# MEMORANDUM

**Subject:** Arroyo Ranch Phase IV

FINAL PLAT

ARROYO RANCH PHASE IV

SHEET  
2  
OF  
2

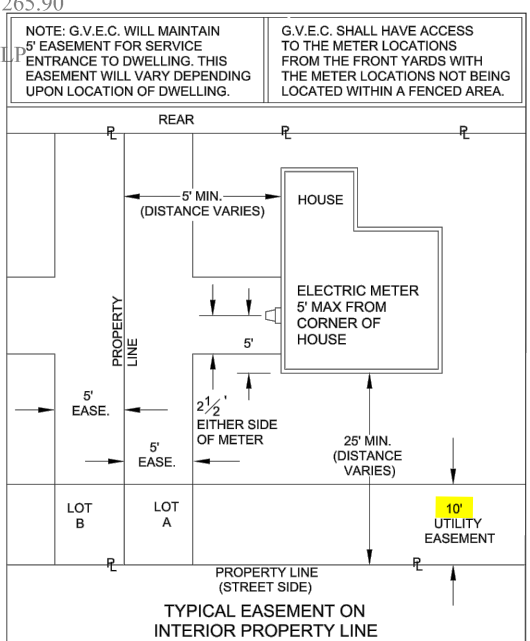
What is the purpose of this detail?  
There is no general condition note in the above list which creates a covenant on this plat for a side yard drainage channel requirement between lots.  
It is not specific to land entitlement and is it warranted on a Subdivision Plat?

Detail does not match over GVEC standards recorded in there service area in 2023/24.

Add dimension of the street, one set per block.

remove label from plat.

please remove all building line indicators from plat diagram.

Remove curve C43, extend tangent lines.

sum of lot rear lines and ROW is 790.00.  
where is the 0.05' as noted in the boundary call?

Remove non-relevant information from the Plat.

Remove curve C40, extend tangent lines.
